Addendum #1

Solicitation #	2018-031
Date Issued	February 26, 2018
Procurement Official	Lynda Robinson
Phone	(803) 476-8140
E-Mail Address	D5bids@lexrich5.org

ADDENDUM NO. 1 BASEBALL AND SOFTBALL SCOREBOARDS DISTRICT FIVE OF LEXINGTON AND RICHLAND COUNTIES SOLICITATION # 2018-031 FEBRUARY 26, 2018

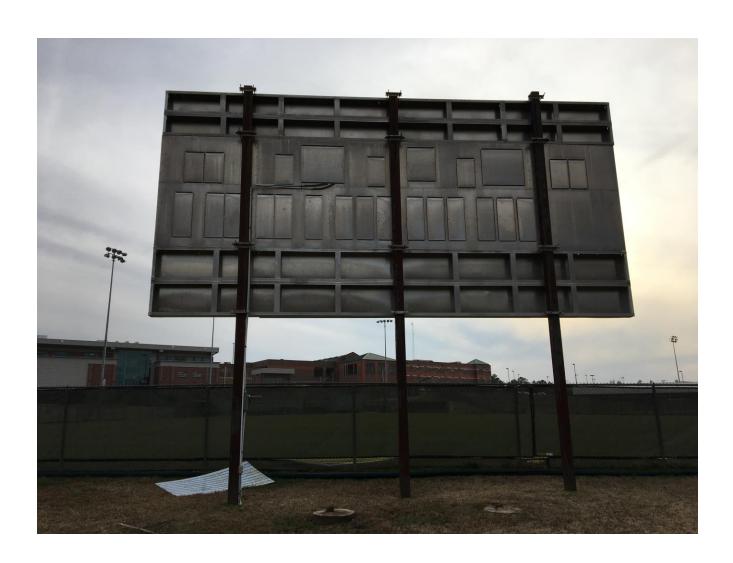
7. **Question:** Also, there is no mention of controls or any other accessories required to operate the boards. Where should I include the pricing for these? (controls and wireless receivers) Are photos of the existing scoreboard structures available to bidders by email? Wireless controls and receivers

Answer: The price for all accessories (controllers and receivers) required to operate the boards should be included in the price of the board. Please note what accessories are included with your bid. Pictures of the existing scoreboards at Dutch Fork High School are included in this addendum. Site visits are recommended at each school.
